Complete Monograph

2024 GROUP A PROPOSED CHANGES TO THE I-CODES

April 7 – 16, 2024
Doubletree by Hilton
Universal Orlando - Orlando, FL

SKETCH RC-01

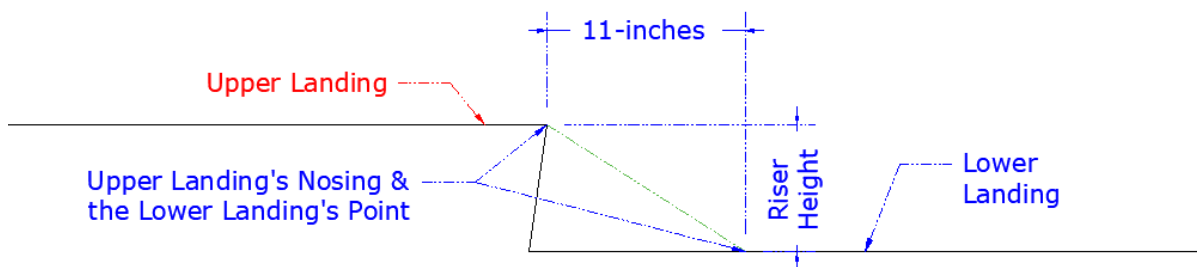
Reason: This code change is centered on clarifying where a bottom riser's, height measurement, is to be taken in conjunction with the lower landing.

To help show a visual representation of the new text, sketch RC-01 included in this reason statement below shows the 3 distinct types of riser measurements within a flight of stairs, in conjunction with a superimposed nosing line as reference for a point of contact on the lower landing, proposed to being revised.

SKETCH RC-02

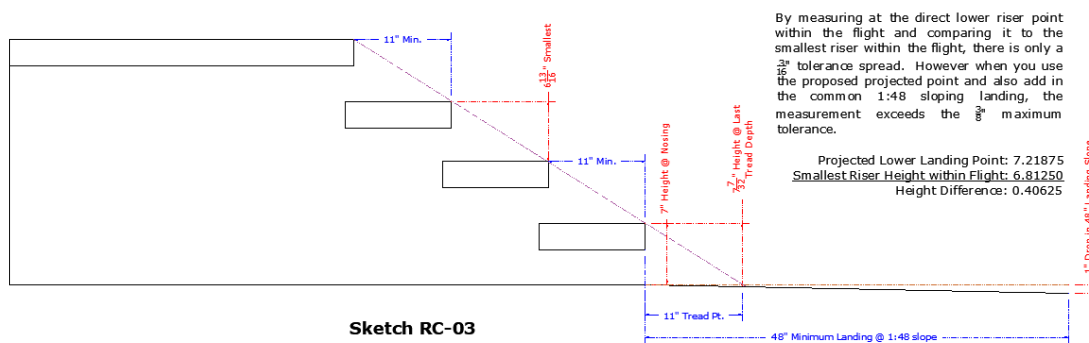
The second sketch RC-02 included in this reason statement is for the exception and explains the same point of measurement for when there is only one single riser between 2 landings and provides direction with the exception when there are no treads, by following the bottom tread requirement in a flight with the specified minimum tread depth of 11 inches for these specific single riser conditions.

FIGURE 1013.6.2 Graphic exit symbol

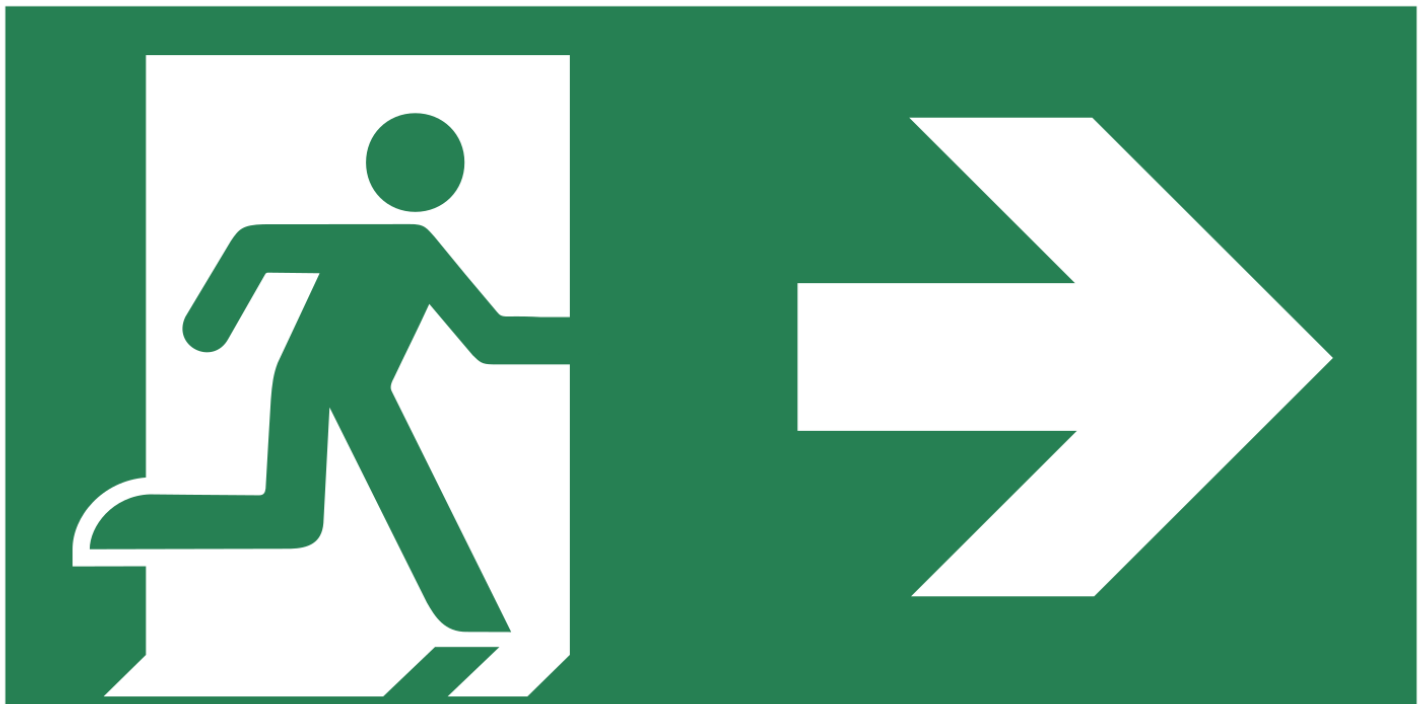
1013.6.2 Exit symbols. Graphical symbol exit signs shall be based on Figure 1013.6.2 and the symbol shall be a minimum of 5.91 inches (150 mm) high.

FIGURE A

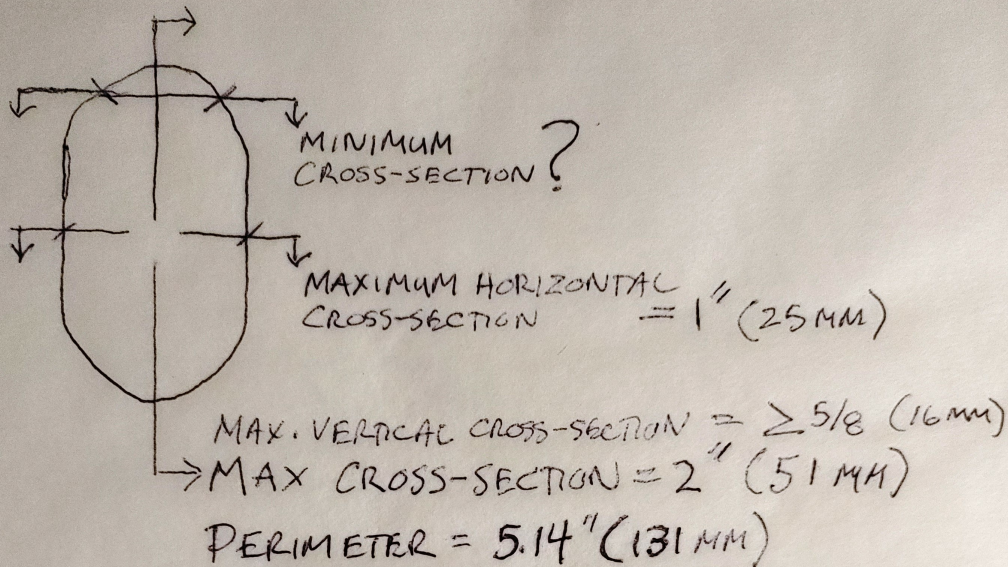
This change is essential to correct an anomaly in the interpretation of the graspability of non-circular type I handrail profiles.

Figure 1 - Landing Guard Height 36"

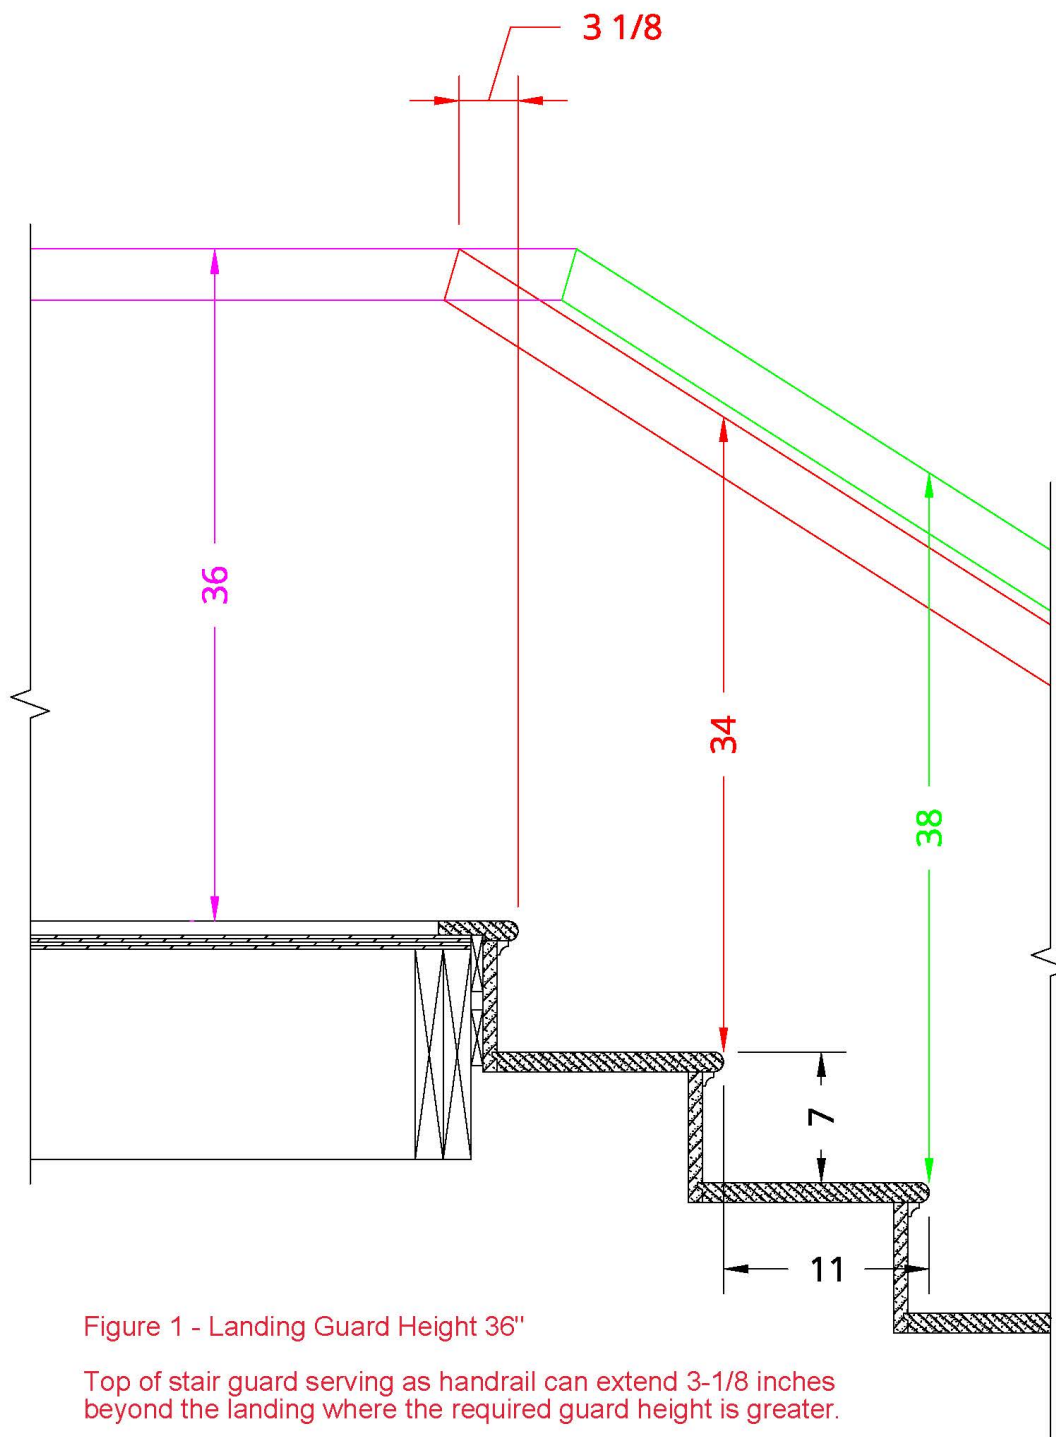
will allow for consistent interpretation of a smooth transition of the handrail/guard of the stair with the guard at an open sided landing and extension of the handrail at constant height. The horizontal dimension of 12 inches provides the necessary distance to configure an extension of the handrail without undue compromise of the guard's function to minimize the possibility of a fall to the floor or grade below. See figures 1 & 2.

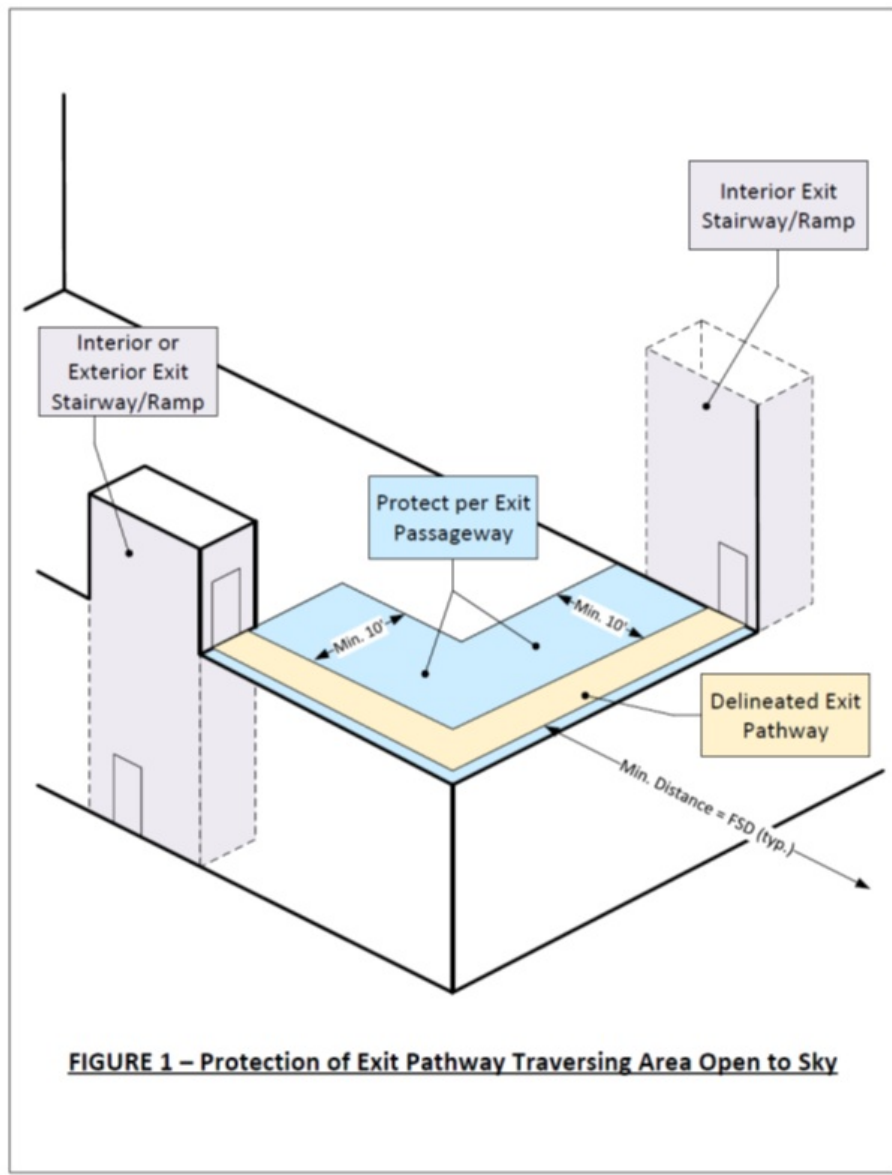
1022.3.2.1 Construction and openings: The floors and walls of the *exit pathway* would be protected like an *exit passageway*, but there would be no ceiling that needs protection. The exit pathway is protected from fires below by requiring the horizontal assembly required in 1024.3 to extend 10 feet from the edge of the pathway. Where there is a minimum of 10 feet of horizontal separation between the edge of the *exit pathway* and other parts of the building, then no walls would be required. However, where *building* walls are less than 10 feet from the edge of *exit pathway*, they must be protected for a vertical distance of 10 feet (see Figure 2 below).

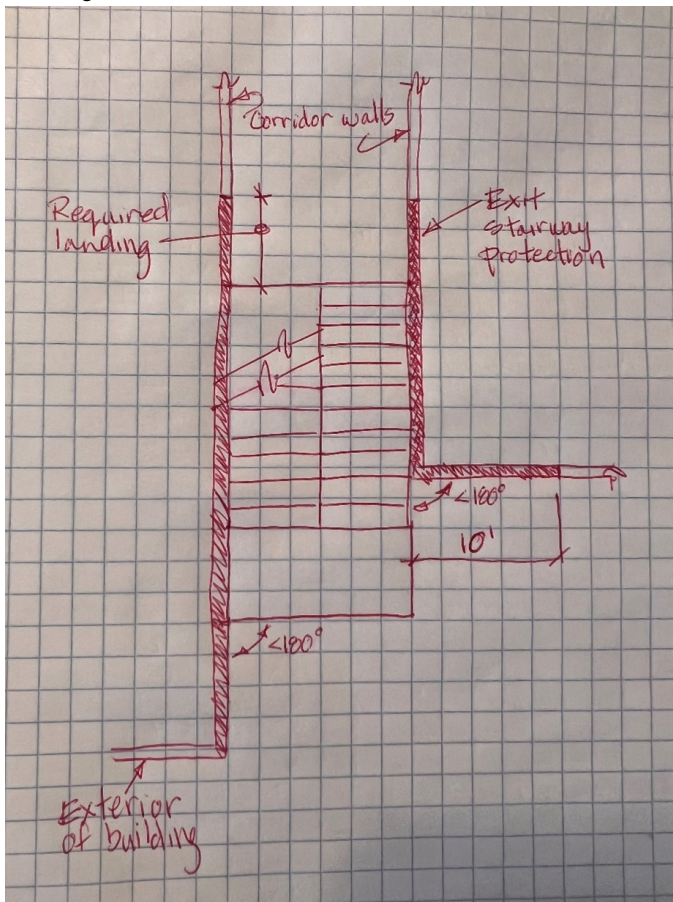
The illustration below gives an orientation of a rotated stair that is partially within the building, illustrating where the rating would stop at the extent of the landing as well as illustrating how the requirement for the ten foot of exterior wall is required to be rated when less than 180 degrees.

Figure 1 – Current code allows fire to go around the fire barrier

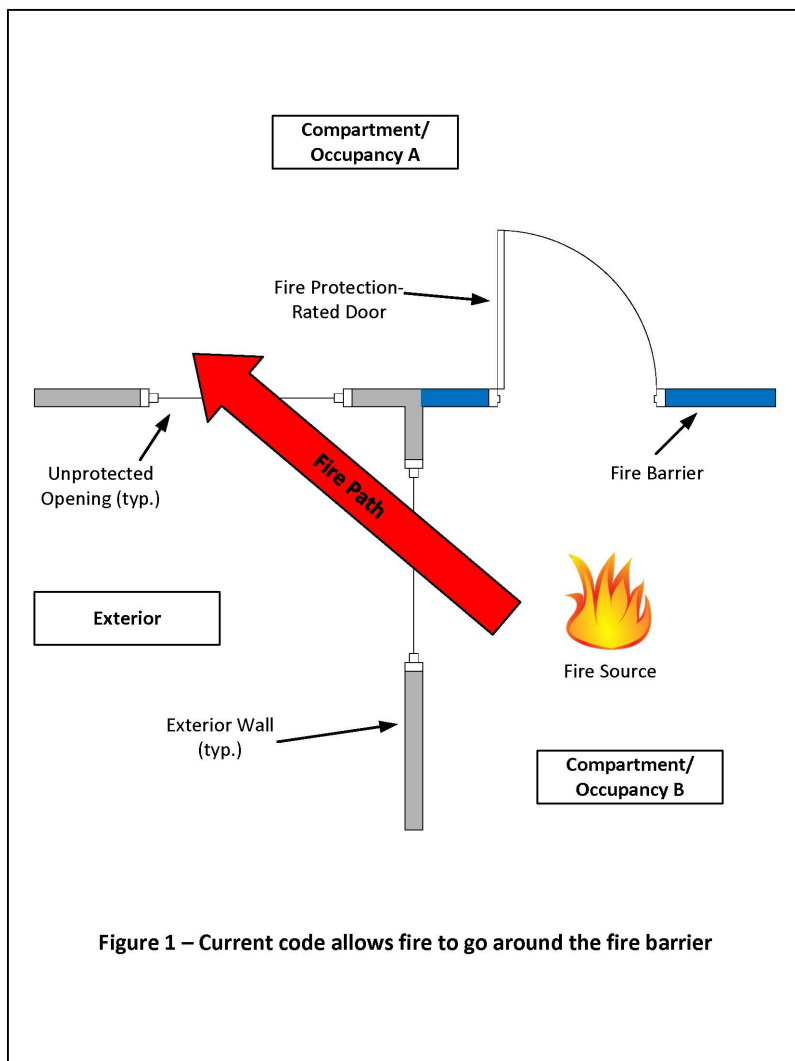
There is an ever-increasing demand for greater density housing. Architects are becoming more creative in their designs and how to maximize the number of units in a given space. This means more units with more uniquely shaped buildings that provide the highest amount of exterior wall area that meet light and ventilation requirements. Requiring the exterior walls and openings of separate dwelling units to meet the fire ratings required as if they are separate buildings is a needed improvement for life safety.

Figure 2 - Unit Separation Wall (Fire Partition)

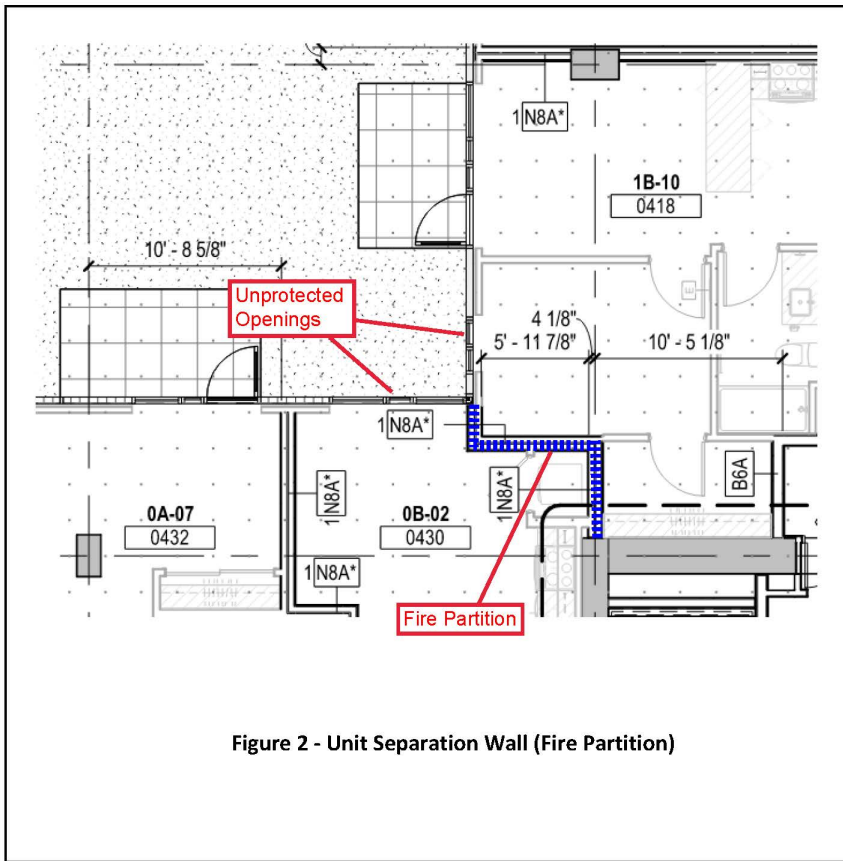
This code change proposal addresses these issues by requiring either 4-foot "wings" on either side of the fire barriers (Section 707.4.2, Item 1) or fire partitions (Section 708.5.1, Item 1) or providing exterior wall ratings and opening protection required by the location of an imaginary property line (Item 2 of each section). Figure 3 shows an example of how this can be done for the fire barrier scenario shown in Figure 1 but could be applied to fire partitions as well. The proposed language is based on the parallel requirements for fire walls and only applies where the exterior walls form an angle of less than 180 degrees. It also does not apply to exterior walls for fire-resistance-rated *shafts*, or separation or enclosure for a *stairway*, *ramp* or *exit passageway*.

FIGURE 1402.3 Wind-driven rain wind speed (m/s) hazard map to determine ASTM E331 test pressure criteria [1 m/s = 2.24 mph]

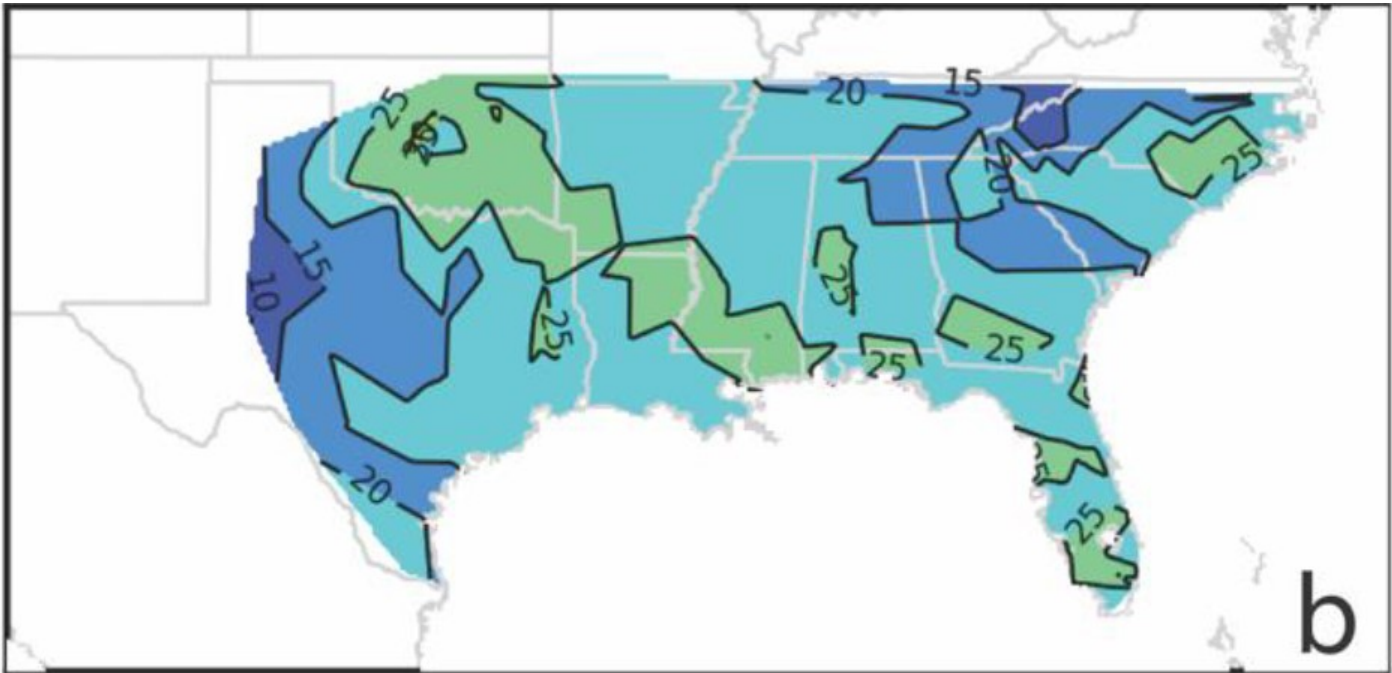
Reason: The code lacks a risk-consistent basis for addressing wind-driven rain and resistance to water intrusion. This proposal provides a wind-driven rain hazard map (Figure 1402.3) that properly characterizes the hazard as it varies across wind-driven rain climatology of the U.S. This map of the southeastern U.S. is a placeholder until a map of the entire U.S. becomes available in 2024.

The proposal “permits” and does not mandate use of proposed Section 1402.3, the wind-driven rain map of Figure 1402.3, or the associated ASTM E331 test pressures of Table 1402.3. Instead, the reference to Section 1402.3 in Section 1402.2 uses permissive language (“shall be permitted”) to allow for current practice to continue unchanged for existing materials and methods recognized in the code. This optional or voluntary approach will allow time for various stake-holders and standards developers to align their standards with this new risk-based approach without changing requirements for materials and methods currently recognized in the code at this time.

1. The ASTM E331 test pressure shall be determined in accordance with Table 1402.3 and Figure 1402.3 or by calculations in accordance with ASCE 7 using a design wind-driven rain wind speed in accordance with Figure 1402.3. The test pressure shall not be less than 2.86 psf (137 Pa) and shall not be required to exceed 12.0 psf (575 Pa).
2. The duration of test shall not be less than 15 minutes. Subsequent tests with increased test pressure shall be permitted with leakage assessment after each test.
3. The tested assembly shall be considered to resist wind-driven rain at the greatest test pressure increment where water did not penetrate the innermost layer intended to provide water resistance protection of the remainder of the wall assembly.

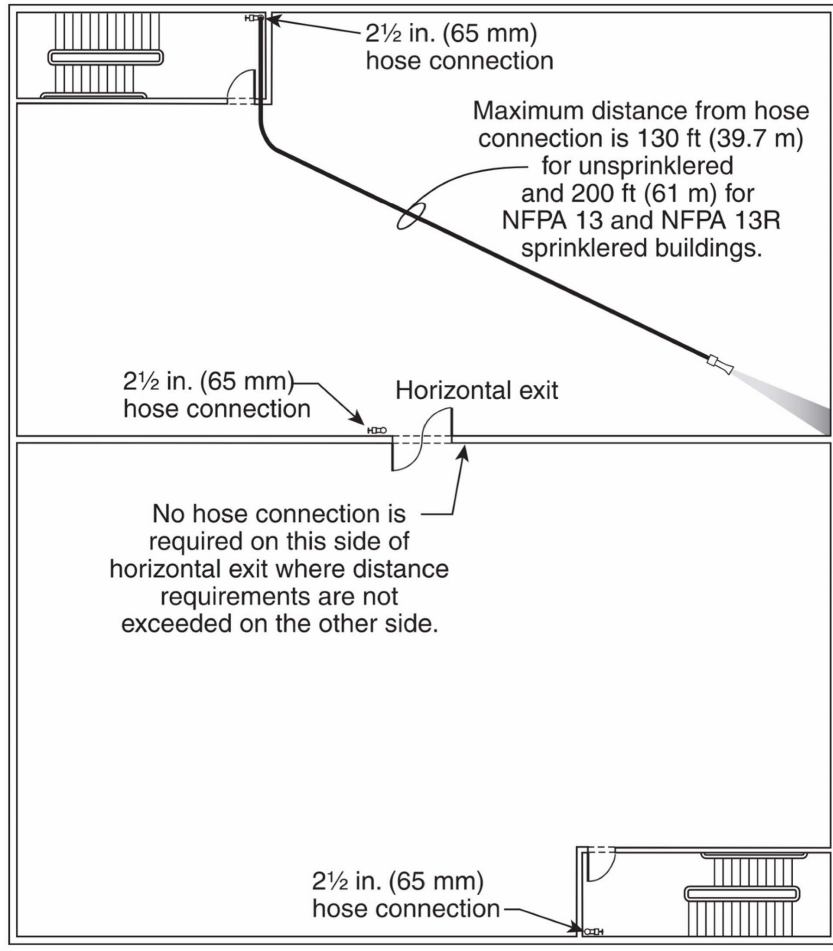
Reason: This change will remove ambiguity from the Exceptions to Item 2 and Item 3 by aligning the code language with NFPA 14, the governing design standard for standpipe systems as prescribed by Section 905.2. These changes, made in an effort to be consistent with NFPA 14, include:

NFPA 14 (2024 Edition) Figure A.9.5.2.2.1 from the NFPA 14 annex demonstrates the intended application of this code change proposal. <https://link.nfpa.org/free-access/publications/14/2024>
